**REVISED RESPONSE TO REQUEST FOR ADDITIONAL INFORMATION****APR1400 Design Certification****Korea Electric Power Corporation / Korea Hydro & Nuclear Power Co., LTD****Docket No. 52-046**

**RAI No.:** 179-8190

**Question No. 09.01.01-23**

**Question No. 09.01.01-25**RAI 9.1.1-24: Dimensional tolerances for the new fuel storage racks**REQUIREMENTS AND GUIDANCE**

Figure 2.4-2 Unit Cell Model for Uncertainty Analysis

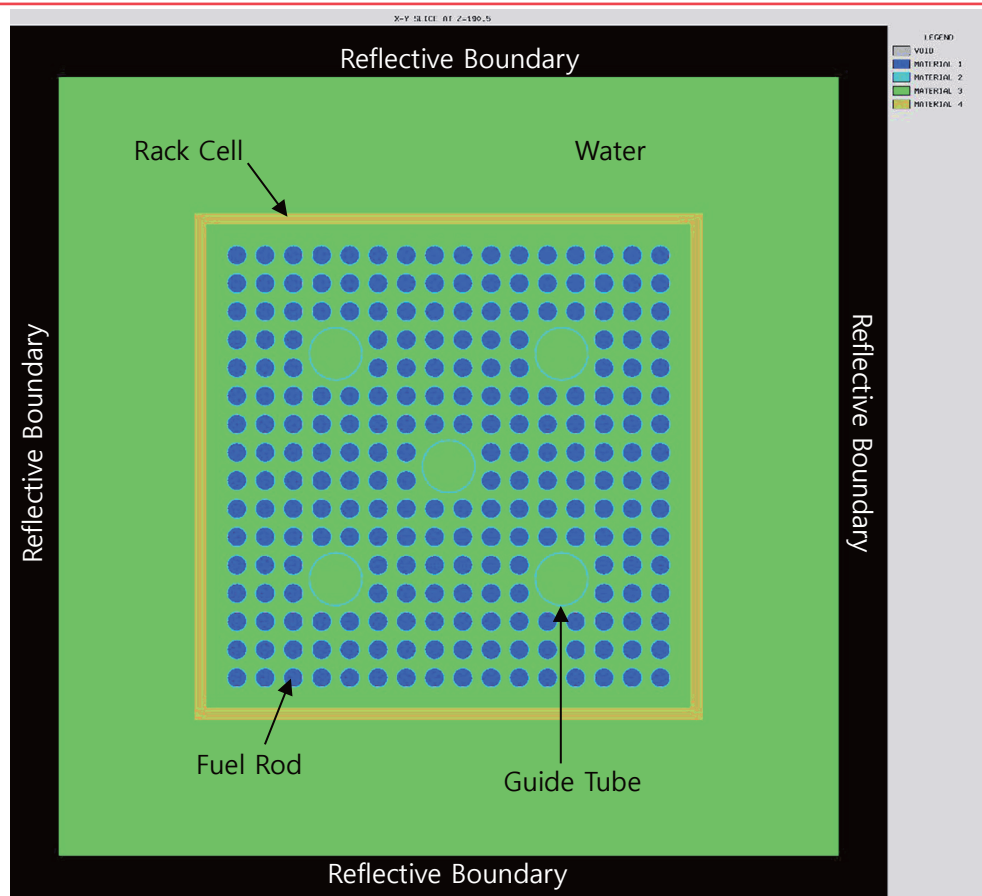
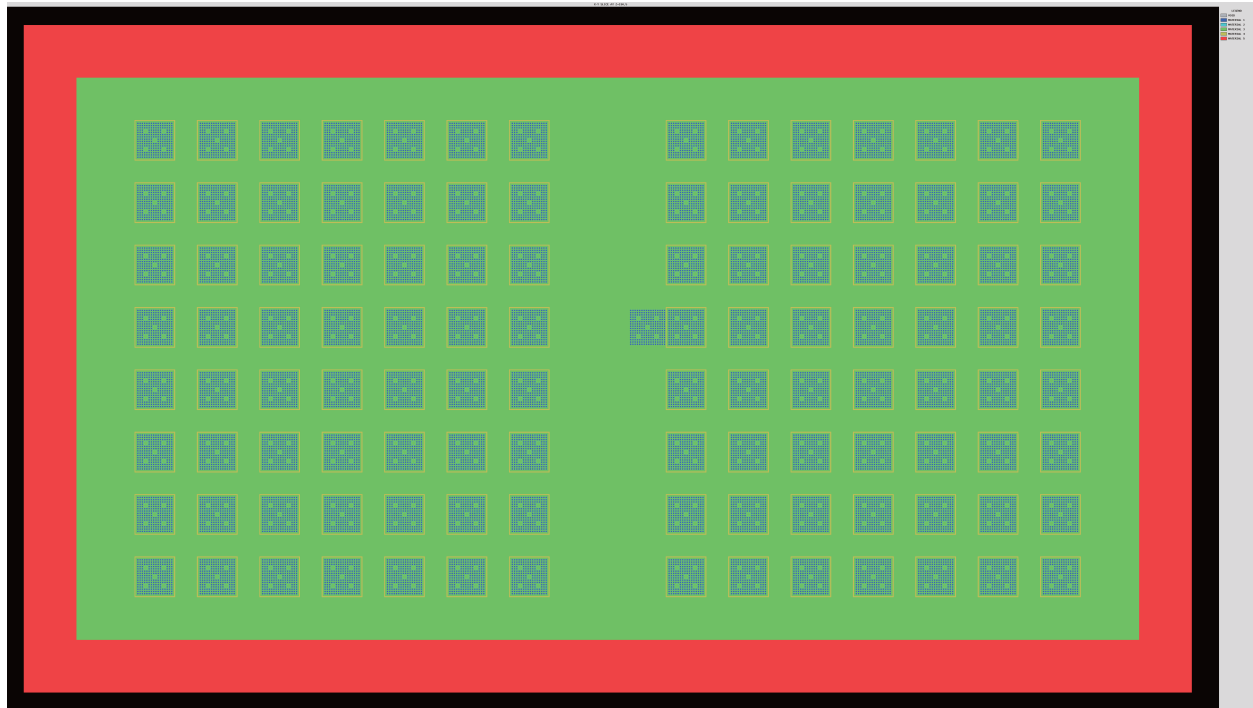
For the new fuel rack criticality analysis, the applicant calculates sensitivities to design tolerances and variations on a model of an infinite-array of rack cells moderated by full-density water. The staff notes that this calculation model neglects the neutronic effects of storage pit concrete and does not address sensitivities under the potentially more limiting accident conditions of optimum moderation by low-density water.

This figure should be replaced with  
page 9 of Attachment.

Sensitivity calculations on a finite array model describing the new fuel racks with storage pit concrete in optimum moderation and full-density water conditions have been performed to obtain uncertainties due to design tolerances. The criticality analysis TeR will be revised to include the sensitivity calculation results.

The uncertainty analyses are performed for the finite array model including NFSP as shown in Figure 2.4-1.

Figure 2.4-3 Criticality Calculation Model for a Dropped Fuel Assembly Accident (Centered)

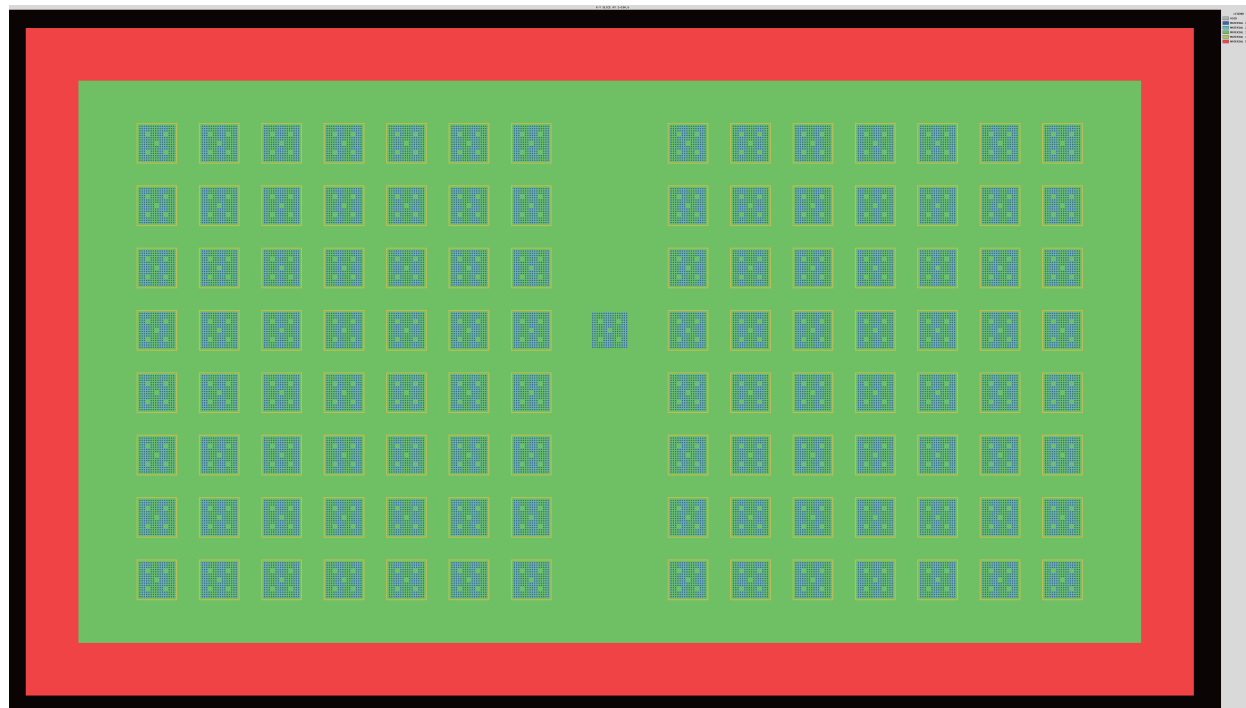
This figure should be added.

Figure 2.4-2 Unit Cell Model for Uncertainty Analysis

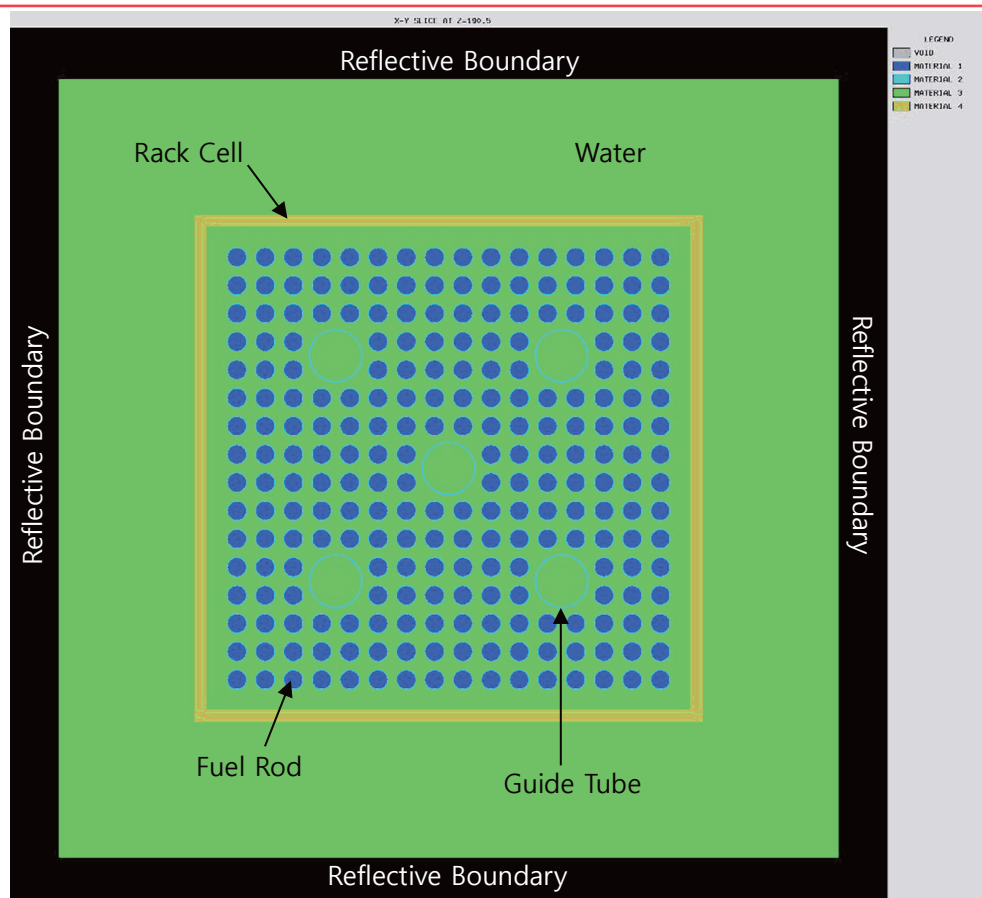
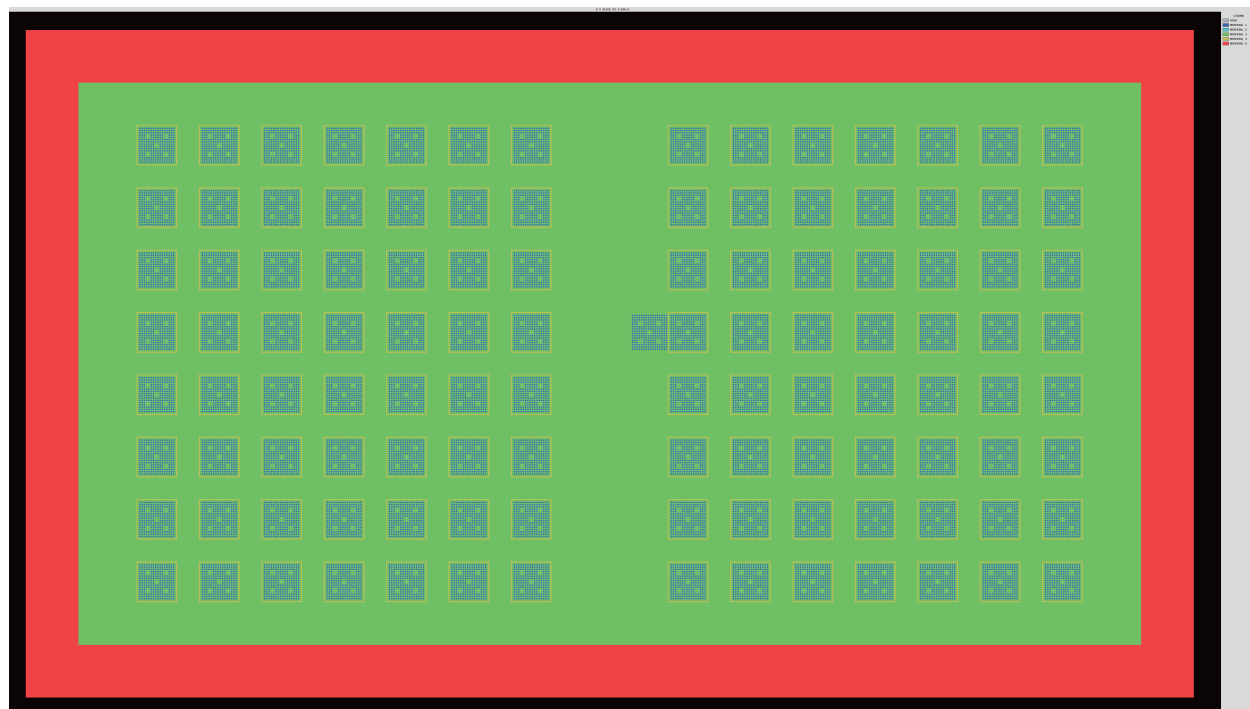
Table 2.4-2 of the criticality technical report provides a list of the mechanical tolerances or variations for the input parameters to the new fuel storage rack model used in a sensitivity analysis for the new fuel storage rack criticality uncertainty evaluation. It is not clear to the staff why the tolerances in this table are not consistent with those for the region I spent fuel storage rack criticality uncertainty evaluations in that the new fuel tolerances do not consider uncertainty in uranium enrichment and both positive and negative tolerances in dimensions such as fuel rod pitch, fuel clad diameter, and rack cell thickness.

This figure should be replaced with  
page 9 of Attachment.

Sensitivity analysis for the new fuel storage rack criticality uncertainty evaluation has been performed to include additional items such as uranium enrichment and both positive and negative tolerances in dimensions such as fuel rod pitch, fuel clad diameter, and rack cell thickness. Criticality analysis TeR will be revised to include the additional sensitivity calculation results.

The uncertainty analyses are performed for the finite array model including NFSP as shown in Figure 2.4-1.

Figure 2.4-3 Criticality Calculation Model for a Dropped Fuel Assembly Accident (Centered)

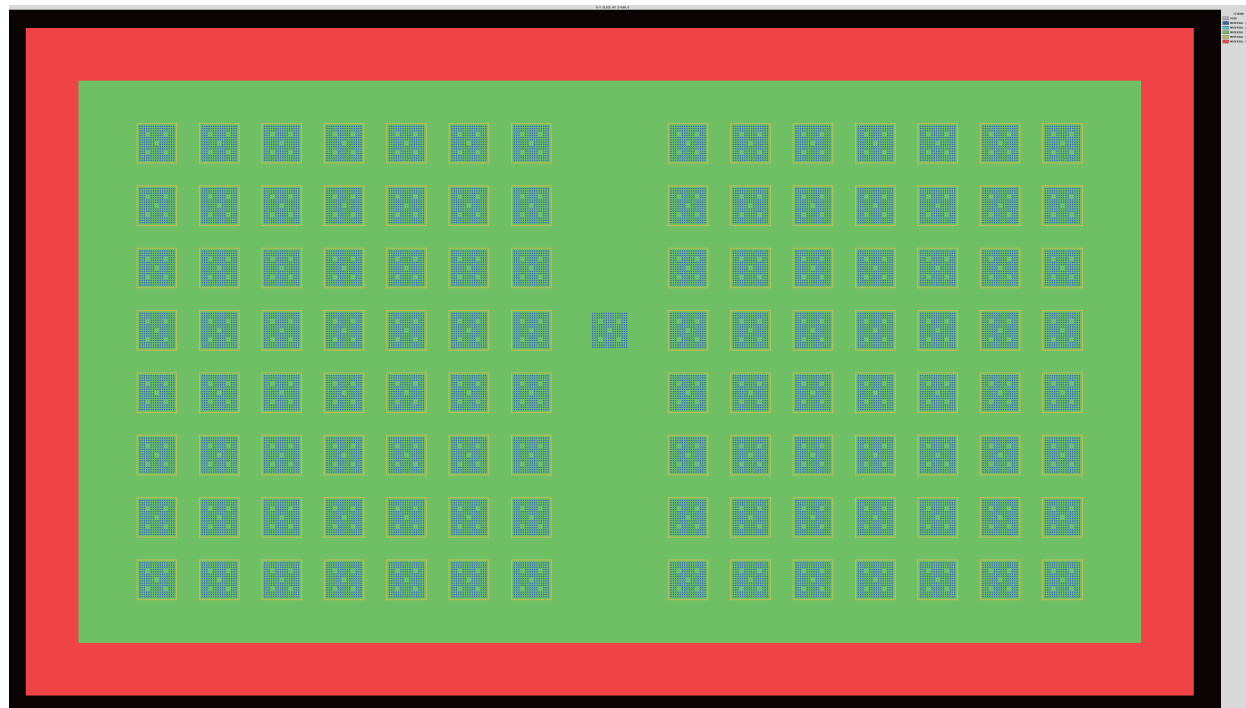
This figure should be added.
